Memo to the Planning Commission

Date:
 April 12, 2011

Case No.:
 2007.0903E

Project Address: Treasure Island/Yerba Buena Island

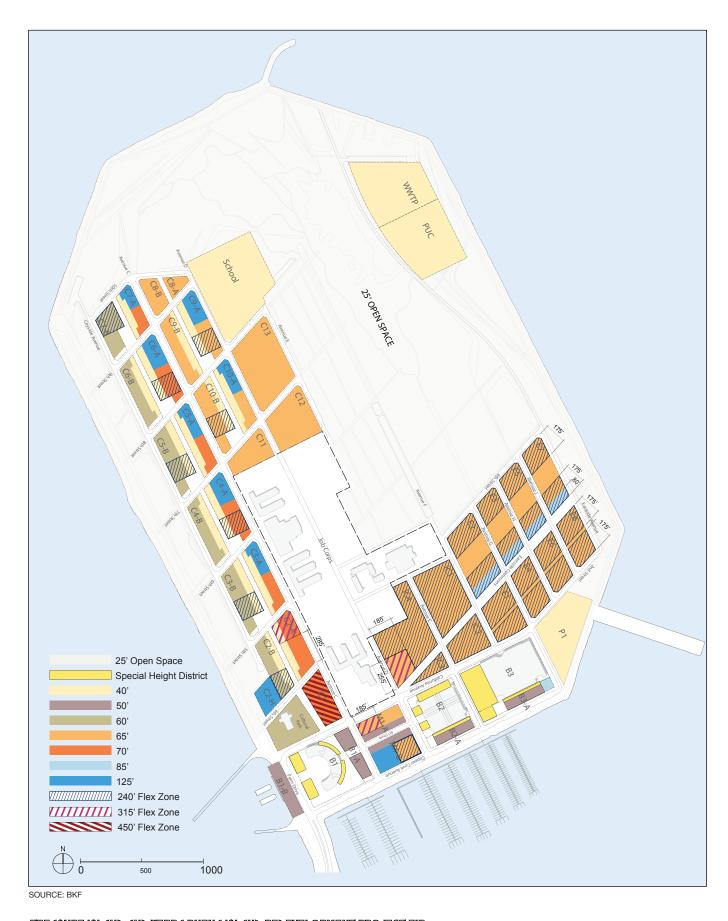
Height limits on Yerba Buena Island, described on EIR p. II.26 and shown in Figure II.6b on p. II.27, would not change. Height limits for residential towers on Treasure Island, described on EIR pp. II.24 – II.26 and shown in Figure II.6a on p. II.25, are proposed to be lowered. The "Main Tower" height zone would be reduced from 650 to 450 feet. The 450-foot tower flex zones would be reduced to a maximum of 315 feet, and the 350-foot tower flex height zones would be reduced to a maximum of 240 feet. The 240-foot tower flex zones would remain. Revised proposed height limits for Treasure Island are shown on Figure 1: Proposed Height Limits on Treasure Island, as Revised, on the following page.

- Reduce height limits on Treasure Island, with a maximum height for the "Main Tower" of 450 feet instead of 650 feet, and maximum heights of 315 feet instead of 450 feet and 240 feet instead of 350 feet; and
- Reduce parking ratios for hotels from 0.8 spaces per room to 0.4 spaces per room, office space from 2 spaces to 1 space per 1,000 sq. ft., and flex space from 2 spaces per 1,000 sq. ft. to 1 space per 1,000 sq. ft. for uses on Treasure Island. No change is proposed for parking on Yerba Buena Island.
